Summary of Items Discussed in 2/2015 APSEC Discussion Forum on 20 March 2015

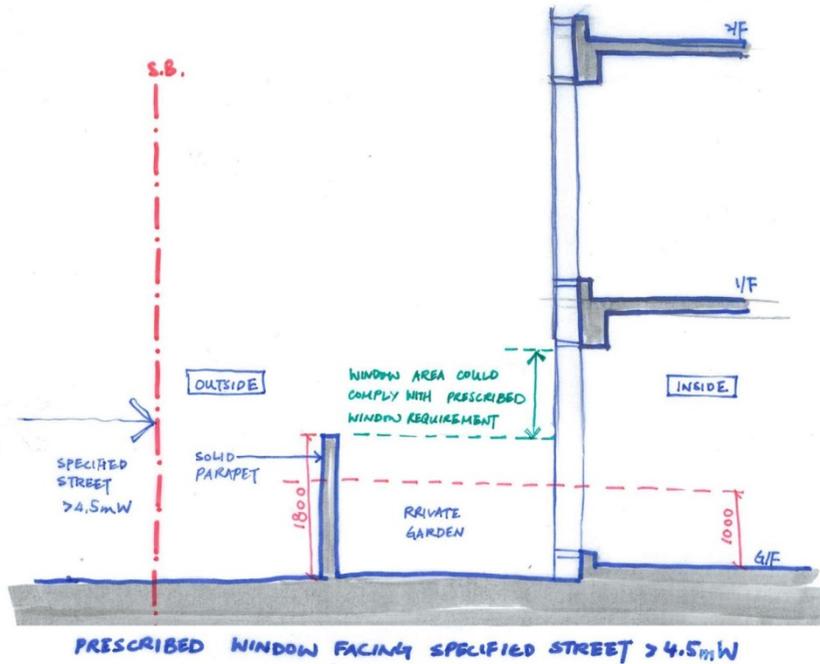
| <p>3.</p> | <p><u>Vertical Green Wall Next to MOE</u></p> <p>A comment from BS states that it is not allowed to have a vertical green wall located next to the exit route because the green wall does not have specified fire resistance rating. Therefore, if the MOE staircase is attached to the vertical green wall, the space along the stairs with a height of 2m should be clear and without the vertical green wall system (see diagram below). As there are many</p> | <p>The BD responded that the proposal to allow a horizontal clearance between the surface of the vertical green wall to the edge of the minimum escape width was acceptable. However, the minimum clearance should be determined on a case-by-case basis as it would depend on the types of the plants and the information provided by the</p> |

precedent cases of having planters next to exit routes, we suggest that a vertical green wall can be located next to an open staircase provided that there is a reasonable clearance, say 300mm, of the vertical green wall from the required discharge width of the staircase.

Fig 1a Building Elevation Showing Movable Sliding Screens / Window Relation

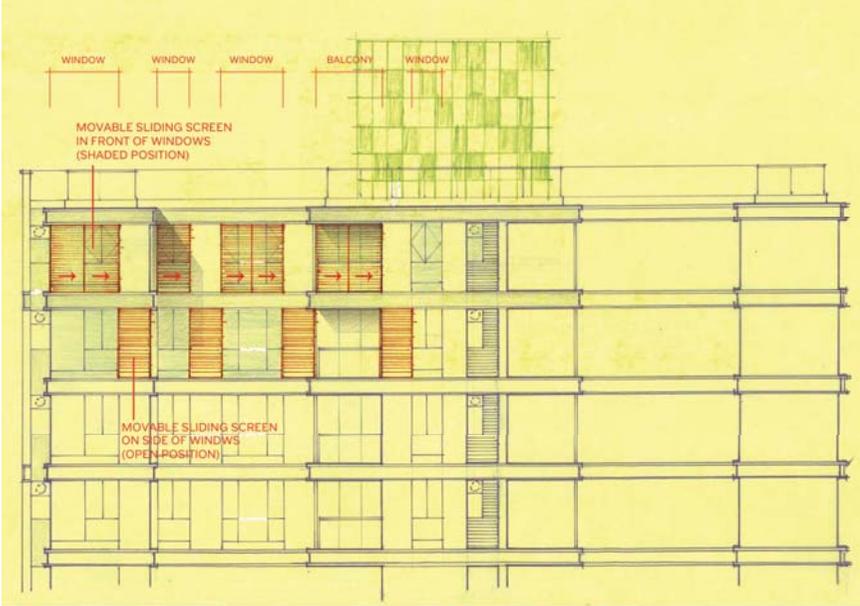
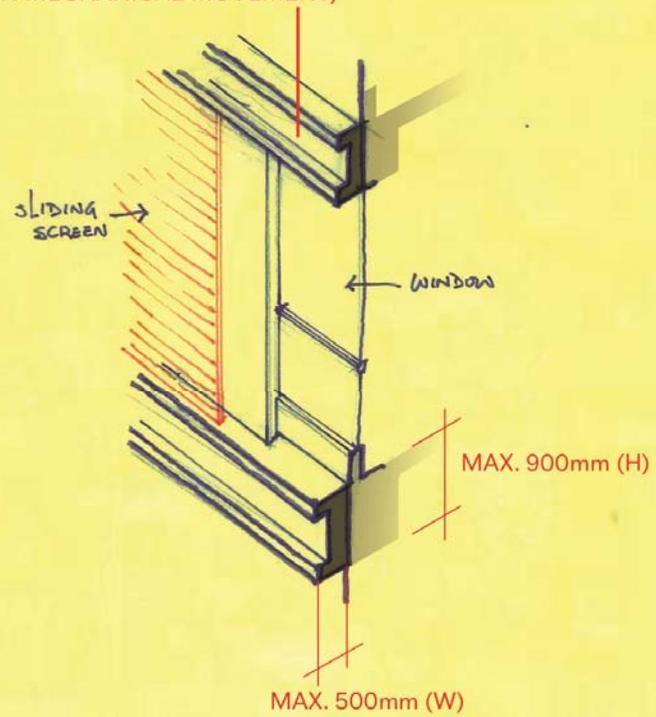
| <p>7.</p> | <p><u>Flexibility for Solar Shading of Windows</u> Under existing guidelines, solar shading of windows is controlled as both building projection and thermal performance of glass where sunshades projecting up to 1.5m are permitted under PNAP APP-19 subject to compliance with APP-67 and APP-156. The limited depth of such sunshades is ineffective against afternoon sunlight that penetrates windows (or even balconies) in low angle and/or sideways, resulting in undesirable heat gain and glare problem in habitable spaces. As shown in Figures 1a & 1b, louver screens in front of windows and balconies provide complete shading regardless of sun angle, and they can be slid away at will from the windows and balconies for a fully open</p> | <p>The BD was receptive with the proposed sliding louvres in front of windows to enhance solar protection on a case-by-case basis subject to submission of detailed information of such system as well as the circumstances of individual cases. While the proposed sliding louvres might be considered as an amenity feature under the PNAP APP-42, considerations should be given to the possible reflection of sunlight from the slanted louvres to the surrounding buildings, and derogation of air ventilation through the louvres. The BD strongly advised that pre-submission enquiry with detailed justifications</p> |

view. These moveable sliding louver screens are common environmentally friendly features seen in Europe and Australia. Figures 2a & 2b show a mechanical example from England and a manual system from Germany. Would BD advise if this system is permissible under current Building Regulations and enjoys similar benefits given by relevant PNAP and JPN for green and innovative building features?

including implications arising of the two aforesaid issues, should be made prior to formal submission.

BASEMENT PLAN

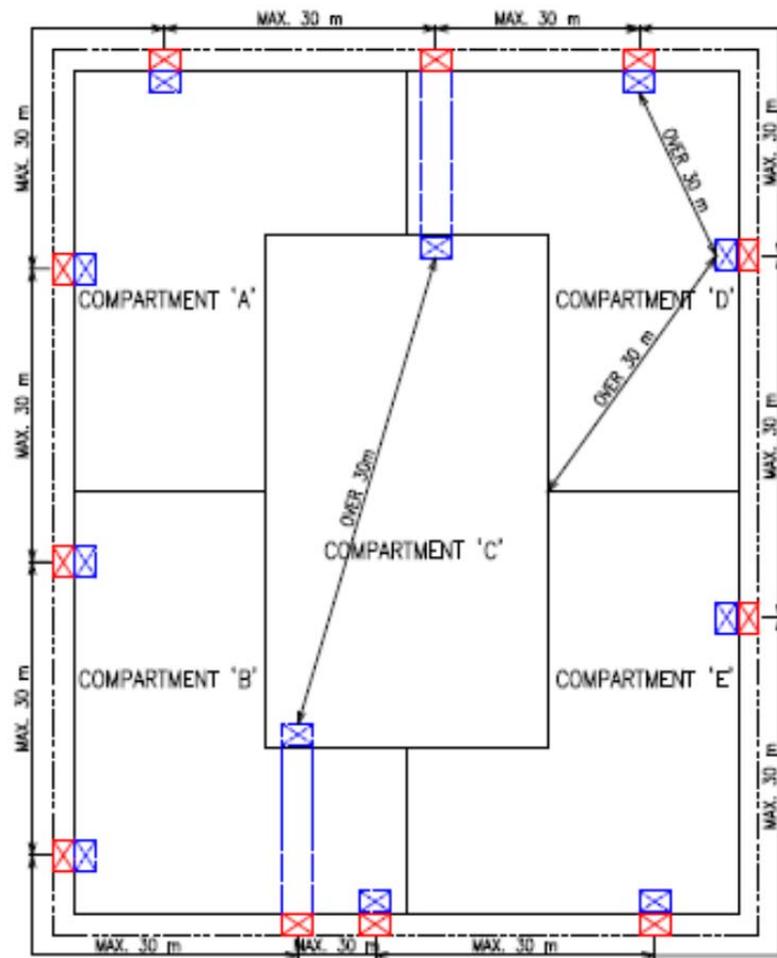
| <p>In Discussion Forum dated 10 Jan 2014, BD clarified that <u>external discharge smoke outlets shall be not more than 30m apart and situated along the street frontages or adjacent to external walls under clause C14.2(a).</u></p> <p>Members encountered project recently where the above is interpreted as all smoke outlets for basement fire compartments have to be located within a frontage of 30m. This seems to be not a correct interpretation of the BD Forum minutes record as it is impractical especially for large development with many fire compartments.</p> <p>Furthermore, for large basement with more than 1 compartment, some of the smoke outlet will be in the form of horizontal 'ducts' running at the high level of the basement and for discharging smoke from the external wall at ground level. In such case, the 'internal smoke outlet' might be arranged as attached. We would like to have clarification whether the distance of different 'internal smoke outlets' within the same compartment can be more than 30m apart. (see Sketch)</p> | <p>outlets within a 30m long frontage. However, each smoke outlet should not be more than 30m away from another smoke outlet along the frontage.</p> <p>The BD advised that the arrangement as shown in the diagram was acceptable under FS Code Clause 14.2(a).</p> |

| 10. | <u>Smoke Outlet</u> | The BD confirmed that it would not be necessary to place all smoke |
